Southern Nuclear Operating Company
Vogtle Electric Generating Plant Units 3 and 4
Request for License Amendment:
Floor Module Connections (LAR-15-012)

Enclosure 2 provides markups depicting the requested changes to the VEGP Units 3 and 4 UFSAR.

Vogtle Electric Generating Plant (VEGP) Units 3 and 4

Floor Module Connections

UFSAR Subsection 3.8.3.5.8.1, Structural Wall Modules - Revise information in the second paragraph, and include the new third paragraph in the location shown below.

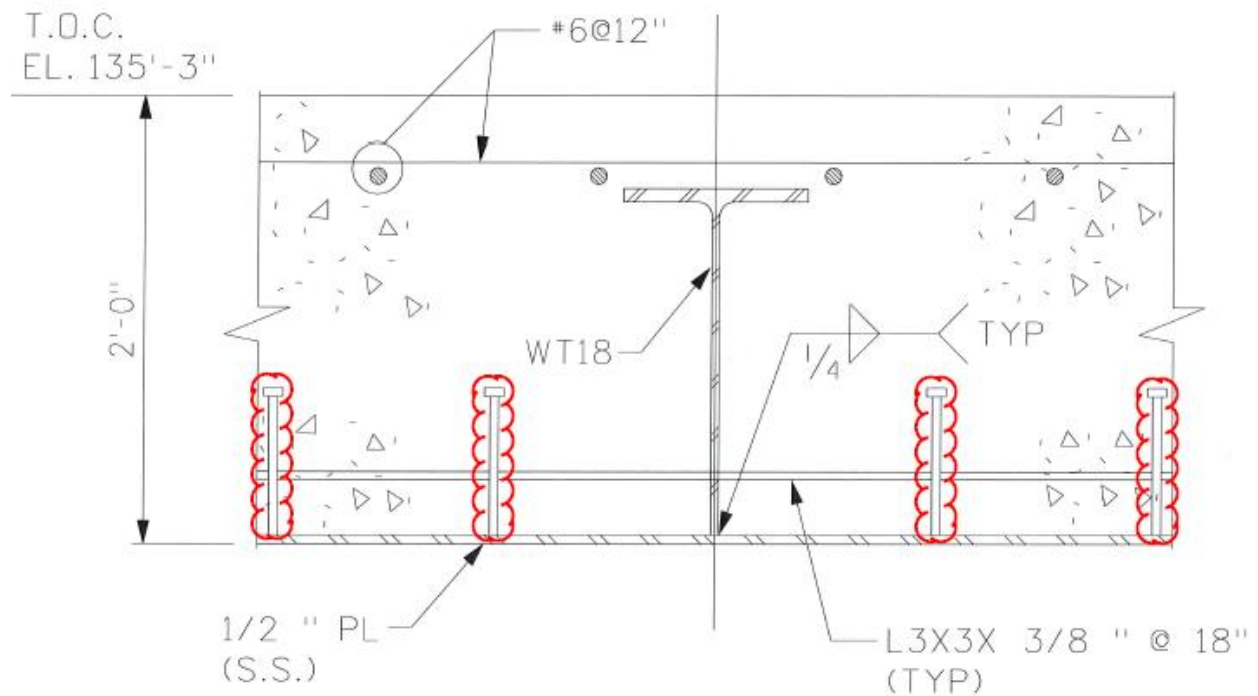
The proposed changes to the second paragraph of UFSAR Subsection 3.8.3.5.8.1 separate the discussion of floor module connections from the wall module discussions. UFSAR Figure 3.8.3-17 is removed from the list of wall module figures. The proposed changes include a revision to note that design elements used in the connections and design details may vary in the implemented design. The proposed changes include adding a sentence in the licensing basis identifying that a key design feature is that design elements provide a direct load path from the floor into the wall. Reference to UFSAR Subsection 3.8.3.1.3 for additional requirements is added to the paragraph. The proposed changes include a revision to note that load capacities of connection design elements satisfy AISC N690 criteria and requirements. Information is also added to reference ACI 349 requirements for reinforcement and standard hooks. Information is added to the description of the floor module connection to include a type of floor where the top of the wall does not extend past the elevation of the floor as a variance to the floor connection designs. Information is added to note that UFSAR Figure 3.8.3-17 is not representative of the connection of the operating deck floor to the walls of the refueling canal and other locations where a floor module rests on top of a structural wall module.

- C. Revise the information and include additional detail in the second paragraph of UFSAR Subsection 3.8.3.5.8.1 "Structural Wall Modules," with the following proposed changes:

1. Remove UFSAR Figure 3.8.3-17 from the list of figures showing wall module information.
 2. Move the sentence describing the floor module connections to be the first sentence of a newly created separate paragraph.

3. Enhance the discussion of the information in UFSAR Figure 3.8.3-17 as part of the new separate paragraph.
 4. Identify that the design elements used and the connection design details vary.

[The details shown in Figure 3.8.3-17 are representative of connections between floors in containment and walls constructed using steel plate concrete composite construction.]* The design details for the floor module are provided for background information and vary based on loading conditions and geometry. The seat angles, beam seats, clip angles, shear plates, shear studs, and reinforcement bars shown in Figure 3.8.3-17 and other design elements are used as required for the connection. A key feature of the connection design is that the design elements provide a direct load path from the floor into the wall. Additional information on the connection design is provided in Subsection 3.8.3.1.3. Details of the connection design, including plate thickness, structural shape type and size, use of specific design elements, and reinforcement arrangement, vary based on local loads. The design implemented in fabrication and construction drawings and instructions may have alternative structural shapes or reinforcement arrangements if they provide sufficient load capacity to satisfy AISC N690 and ACI 349 criteria and requirements. Figure 3.8.3-17 is not representative of the connection between the operating deck floor and the wall modules that form the sides of the refueling canal because these walls do not extend above the floor and the major connection design elements are located within the thickness of the wall and not attached to the faceplates.

UFSAR Section 3.8, Figure 3.8.3-3, Structural Floor Module - Revise information for the structural floor module as shown below.

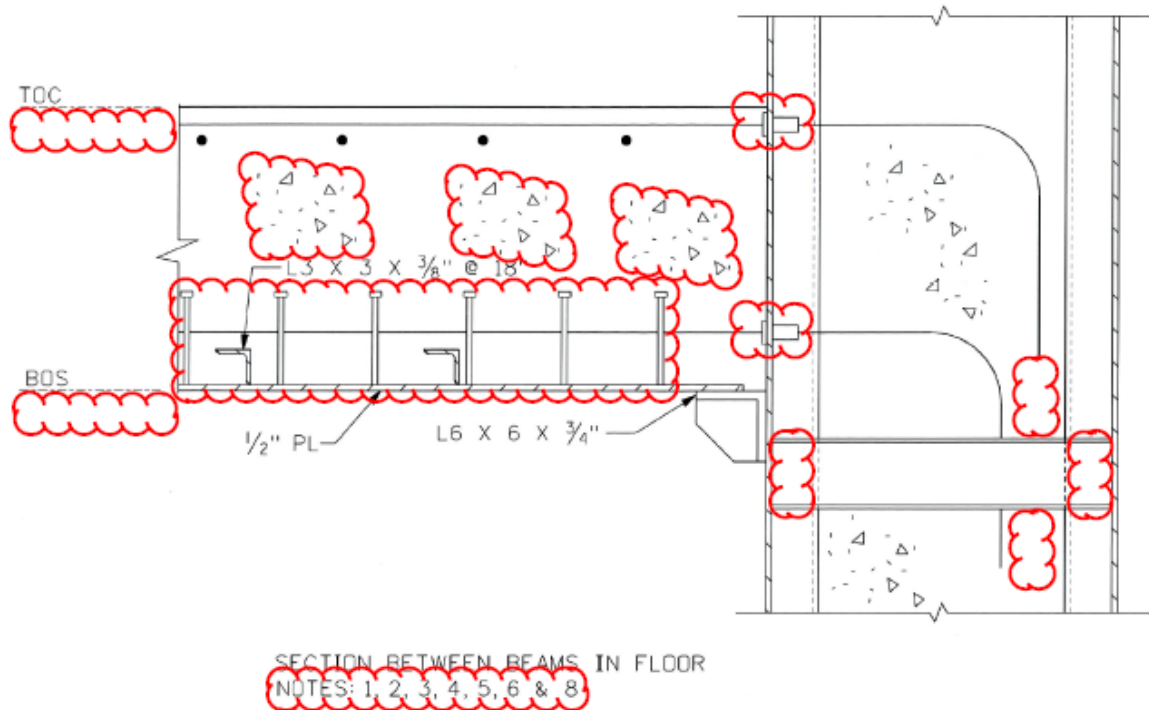
UFSAR Figure 3.8.3-3 shows the floor module design and is revised to include the shear studs attached to the bottom steel plate of the module.

- D. Revise UFSAR Figure 3.8.3-3 to add shear studs on top of the bottom steel plate of the floor module.

UFSAR Section 3.8, Figure 3.8.3-17, Sheet 1 of 2 [*Structural Modules –Design Details Standard Floor Connection*]* - Revise information for the SECTION BETWEEN BEAMS IN FLOOR as shown below.

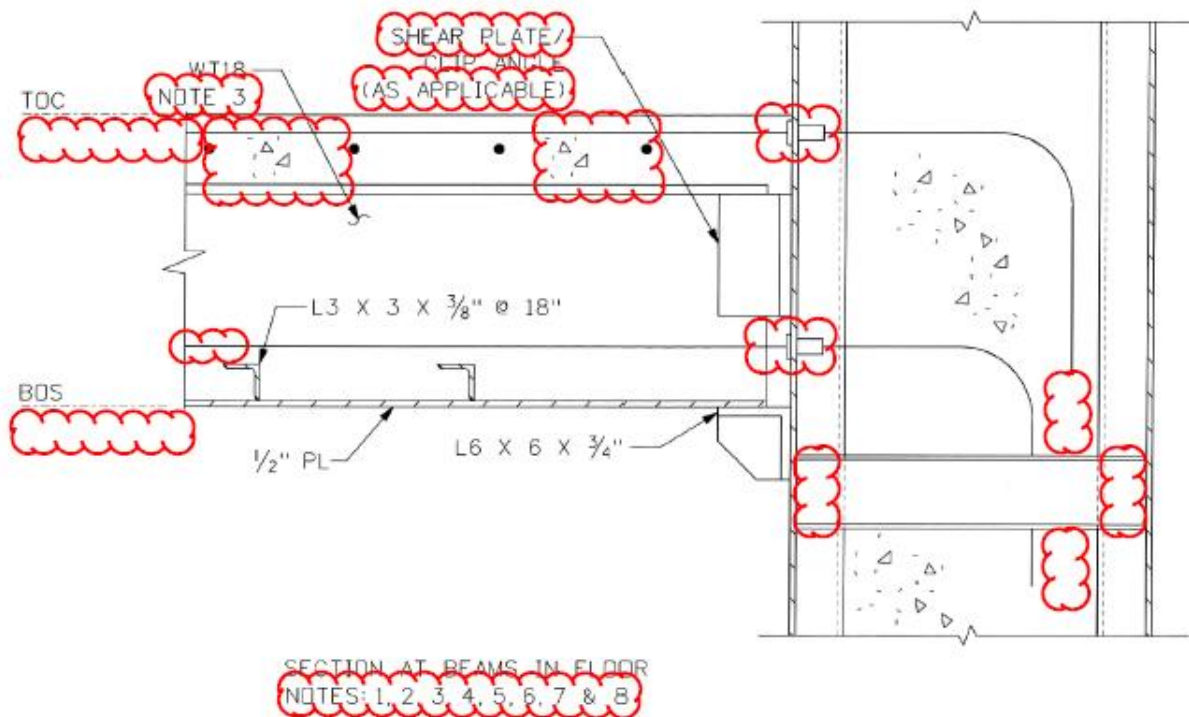
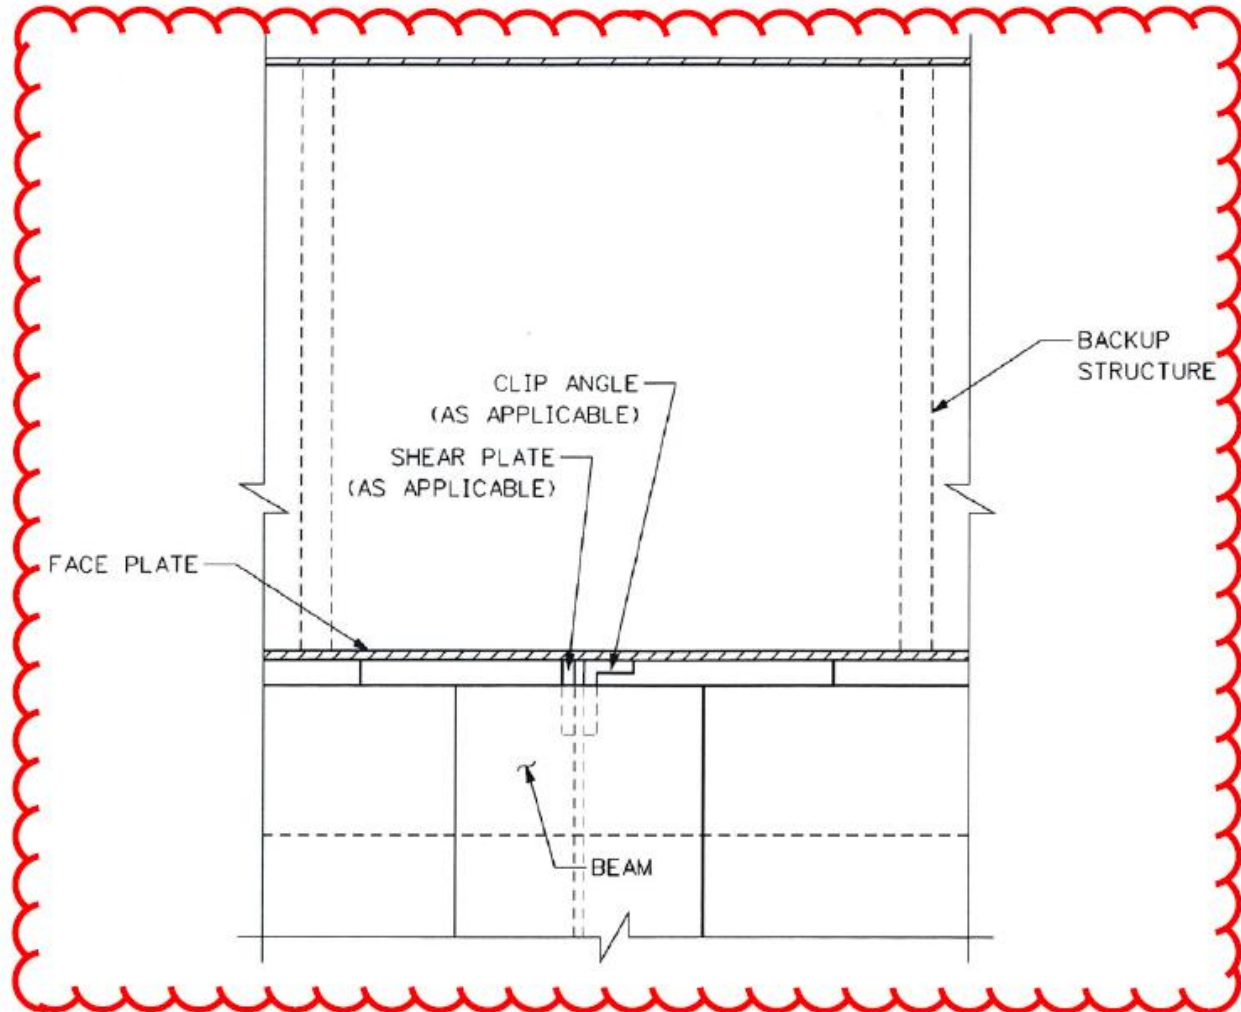
There are proposed changes in the design of the structural wall module faceplate connection with the floor modules shown in UFSAR Figure 3.8.3-17, Sheet 1. The figure shows seat angles welded to the vertical face of structural wall modules under the ends of the floor modules with a clip angle connecting the floor module beam to the wall module. The proposed design changes remove the requirement to use these clip angles and include the use of shear plates as a design variation. Notes are added to the figure to identify variation in the connection design. The proposed changes revise the representation of the truss channels to extend to the inside surface of the faceplates. The figure is also revised to remove the elevations for top of concrete (TOC) and bottom of steel (BOS) on Sheet 1 and Sheet 2 because the wall module to floor module connection designs are used at more than one floor elevation. The representation of the reinforcement hooks length is changed to be consistent with the ACI standard for standard hooks. The representation of reinforcement connector on the faceplate is changed to be consistent with the type of connector used.

3. Add “SHEAR PLATE” and the term “(AS APPLICABLE)” to the clip angle designation where shown on Sheet 1 and Sheet 2. Revise the figure to show a clip angle and a shear plate instead of two clip angles in the connection in Sheet 2, TOP VIEW AT BEAMS IN FLOOR and in Section A.

5. Redraw reinforcement hooks to show proper length for standard hooks in both sections on Sheet 1 and in SECTION BETWEEN BEAMS IN FLOOR on Sheet 2.
 6. Change representation of reinforcement connector on faceplate to show representative configuration of the connector in both sections on Sheet 1 and in SECTION BETWEEN BEAMS IN FLOOR on Sheet 2.

17. Add designation of reinforcement bar size (#11) to Sheet 2 SECTION BETWEEN BEAMS IN FLOOR.
18. Add shear studs attached to the bottom steel plate of the floor module in SECTION BETWEEN BEAMS IN FLOOR in Sheet 1 and 2.

1. DETAILS SHOWN ARE REPRESENTATIVE OF FLOOR MODULES AT EL 107'-2" AND 135'-3" AND THE CONNECTIONS OF FLOOR MODULES TO WALL MODULES INSIDE CONTAINMENT. REFER TO SUBSECTION 3.8.3.1.3 AND OTHER NOTES FOR ADDITIONAL INFORMATION ABOUT DESIGN DETAILS AND VARIATIONS FOR FLOOR MODULE TO WALL MODULE CONNECTIONS. DETAILS ARE NOT REPRESENTATIVE OF THE CONNECTION BETWEEN THE OPERATING DECK FLOOR AND THE WALL MODULES THAT FORM THE SIDES OF THE REFUELING CANAL; SEE SUBSECTION 3.8.3.5.8.1.

6. THE DETAIL DESIGN, LOCATION, AND ATTACHMENT OF THE FLOOR AND BEAM SUPPORTS ARE DESIGNED TO THE REQUIREMENTS OF AISC N690. SUPPORT CONFIGURATIONS, INCLUDING THE USE OF PLATES, STRUCTURAL SHAPES, AND STIFFENERS, ARE BASED ON LOADING AND LOCAL GEOMETRY CONSIDERATIONS.

UFSAR Section 3.8, Figure 3.8.3-17, Sheet 2 of 2 [*Structural Modules –Design Details Heavily Loaded Floor Connection*]* - Revise information for the TOP VIEW AT BEAMS IN FLOOR as shown below.

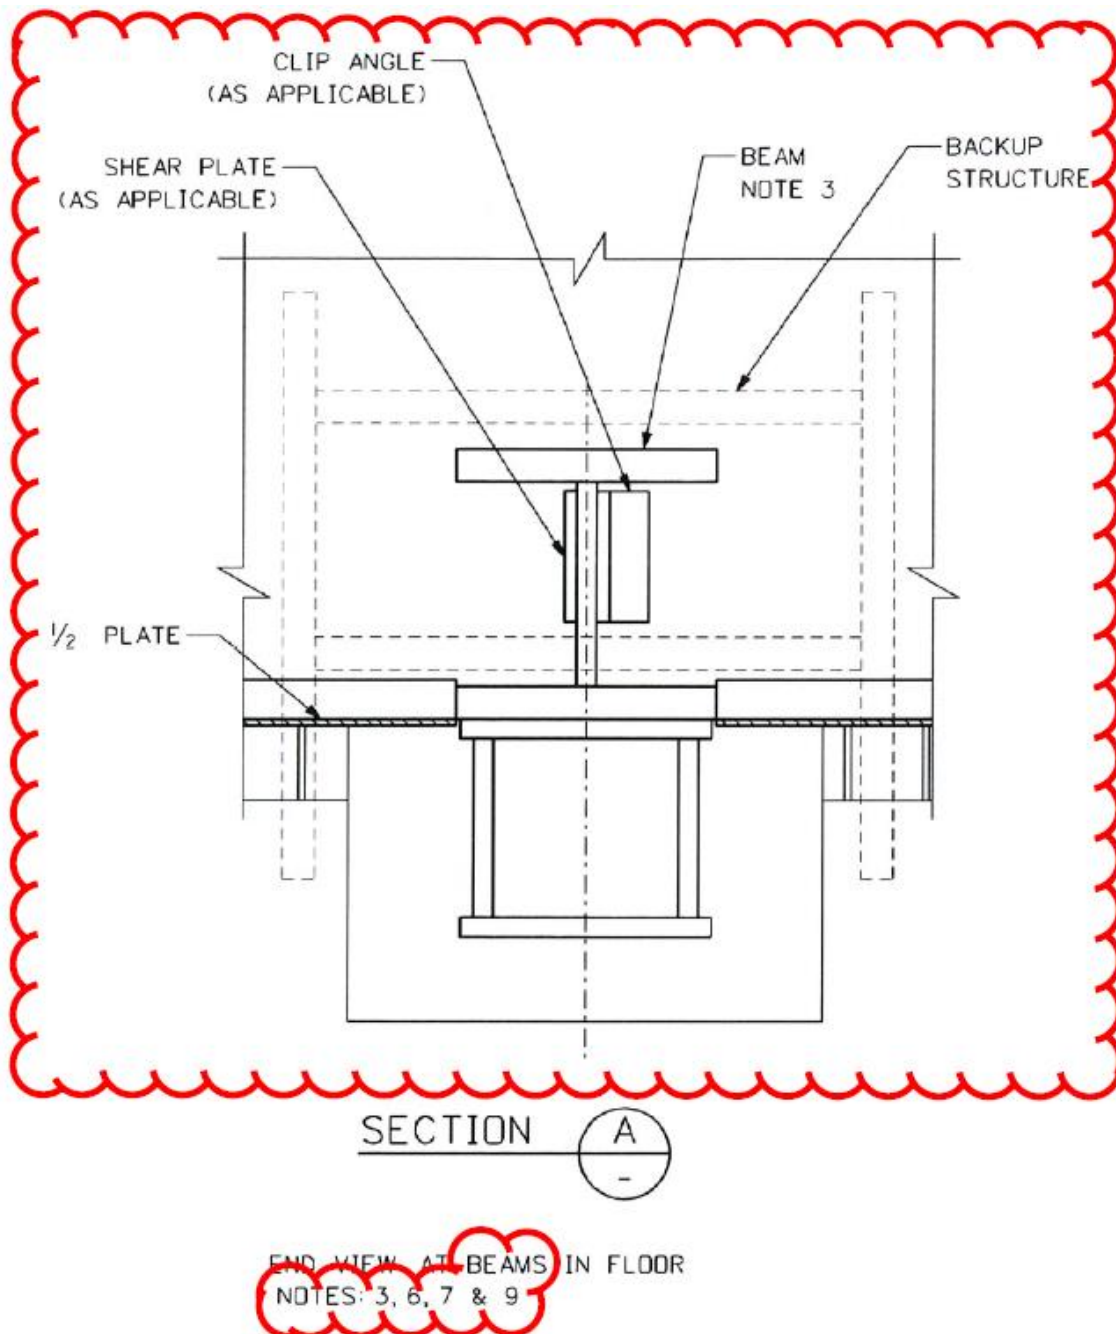
The proposed changes in the design of heavily loaded floor modules, shown in UFSAR Figure 3.8.3-17, Sheet 2, are representative for "heavily loaded" floor connections. The figure shows two clip angles for the beam connection to a structural wall module. The proposed design changes reconfigure the connection, add the use of shear plates, and remove one of the clip angles shown for the connection. At the beam location the seat angle supporting the beam is changed to show a beam seat. The changes reconfigure the backup structure and remove the plate thickness for the back-up structure because there is a large variation in the detail design of the internal backup structures. The sizes of the angle and channel that are part of the truss in the wall modules are removed because this information is included in Figure 3.8.3-8. The backup structure shown in the module wall is a representative design for the connection and the details for the design implemented may vary from that shown in the figure. The

changes to the figure remove reinforcement bars at the beam locations connected to the faceplates and the associated hooks within the wall modules. In some locations, reinforcement bars connected to the wall module are not provided immediately adjacent to the beam. Consistent with Note 5 added to the figure, where reinforcement is used, the size, spacing, and length satisfy ACI 349 requirements. Symbols identifying the location of Section A and representing concrete are moved on the figure to clarify the design. Dimensions of structural angles and reinforcement bars are added and moved on the figure due to removal of this information in other portions of the figure. Use of the term “plate girder” is replaced with “beam” on UFSAR Figure 3.8.3-17, Sheet 2. This is consistent with the use of the term “beam” on Sheet 1 of the figure.

4. Redraw Section A and “TOP VIEW AT BEAMS IN FLOOR” on Sheet 2 to show connection design based on design finalization. The changes remove the reinforcement adjacent to the beam section and remove the connectors adjacent to the beam in Section A.

7. Remove the dimensions from the wall module internal structure and from the plate thickness of backup structure from Top View on Sheet 2.
 8. Redraw the representation of the wall module internal channels to extend to the faceplate in both sections on Sheet 1 and in SECTION AT BEAMS IN FLOOR and SECTION BETWEEN BEAMS IN FLOOR on Sheet 2.

11. Remove the reinforcement bars in the floor and the reinforcement connectors in the Top View, Section A, and in the SECTION AT BEAMS IN FLOOR on Sheet 2.

UFSAR Section 3.8, Figure 3.8.3-17, Sheet 2 of 2 [Structural Modules – Design Details Heavily Loaded Floor Connection]* - Revise information for the END VIEW AT BEAMS IN FLOOR as shown below.

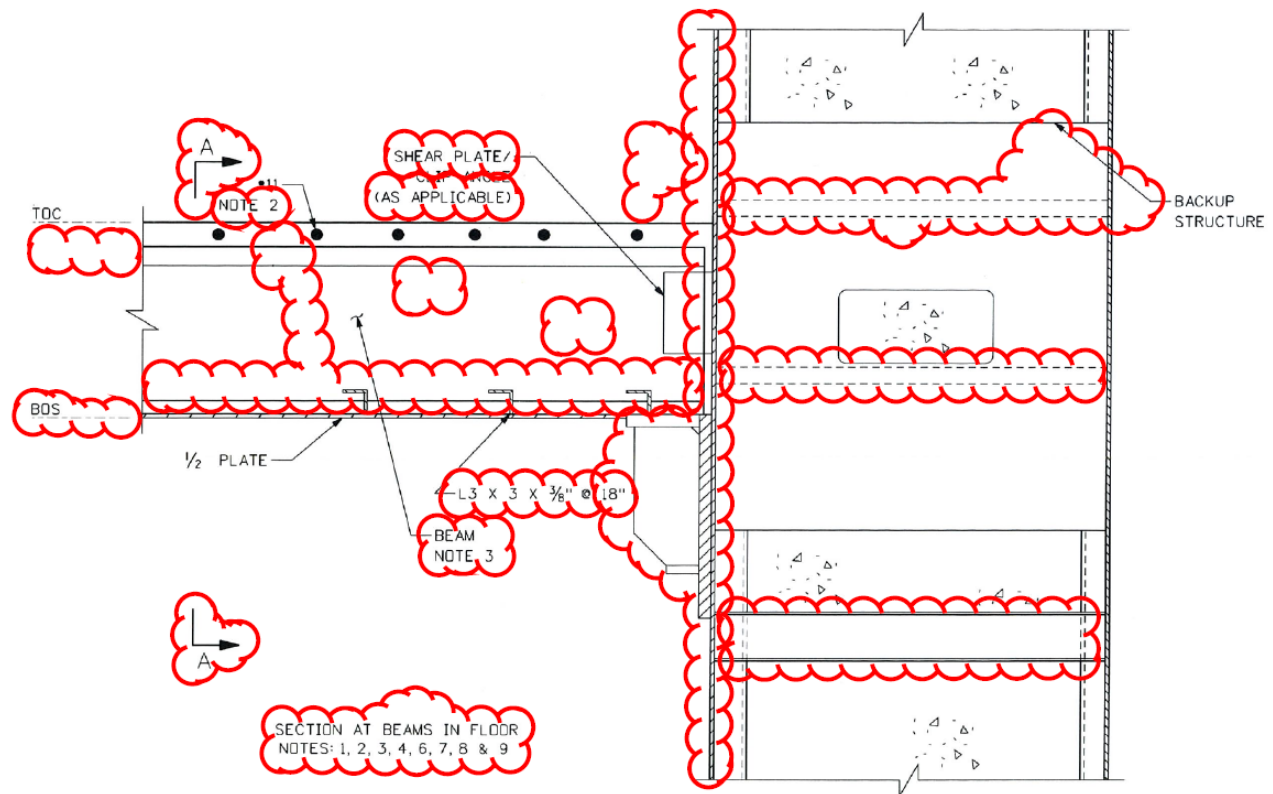
1. Replace the term “Plate Girder” with “Beams” in the Labels for the section views shown on Sheet 2.
 2. Replace the identifier “PLATE GIRDER” with “BEAMS” in three of the section views on Sheet 2.

9. Redraw the representation of the backup structure in Top View, SECTION AT BEAMS IN FLOOR, and Section A on Sheet 2.
 10. Redraw the representation of the wall module structure on Sheet 2 to move and reconfigure the plates applied or overlaid onto the faceplates on the connection side of the wall module in TOP VIEW AT BEAMS IN FLOOR, SECTION AT BEAMS IN FLOOR and SECTION BETWEEN BEAMS IN FLOOR.

UFSAR Section 3.8, Figure 3.8.3-17, Sheet 2 of 2 [Structural Modules – Design Details Heavily Loaded Floor Connection]* - Revise information for the SECTION AT BEAMS IN FLOOR as shown below.

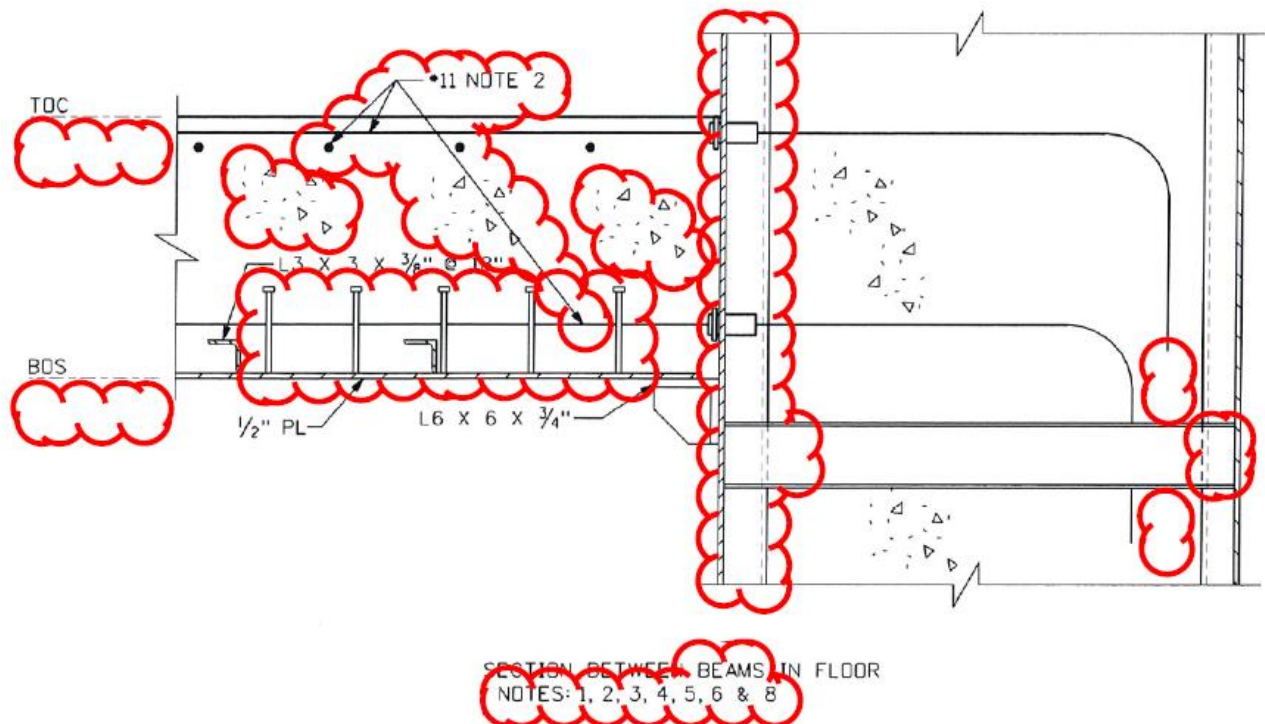
12. Remove the elevations for TOC (top of concrete) and BOS (bottom of steel) on Sheet 1 and Sheet 2.
 13. Move arrows identifying Section A in SECTION AT BEAMS IN FLOOR on Sheet 2 to clarify the location of Section A.

14. Remove symbols indicating concrete from Sheet 2 SECTION AT BEAMS IN FLOOR and add the symbols indicating concrete to Sheet 2 SECTION BETWEEN BEAMS IN FLOOR and Sheet 1 SECTION BETWEEN BEAMS IN FLOOR to be consistent with the materials at those locations.

15. Add the dimensions for the angles welded to the floor in Sheet 2, SECTION AT BEAMS IN FLOOR.
16. Replace the seat angle with a beam seat in Sheet 2, SECTION AT BEAMS IN FLOOR.

6. THE DETAIL DESIGN, LOCATION, AND ATTACHMENT OF THE FLOOR AND BEAM SUPPORTS ARE DESIGNED TO THE REQUIREMENTS OF AISC N690. SUPPORT CONFIGURATIONS, INCLUDING THE USE OF PLATES, STRUCTURAL SHAPES, AND STIFFENERS, ARE BASED ON LOADING AND LOCAL GEOMETRY CONSIDERATIONS.

8. THE THICKNESS OF THE ADJACENT WALL IS BASED ON THE WALL DESIGN REQUIREMENTS AND LOCATION.
9. THE BEAM SEAT SHOWN IS NOT USED AT ALL BEAM LOCATIONS. THE SEAT ANGLE SHOWN ON SHEET 1 IS USED AT OTHER LOCATIONS.
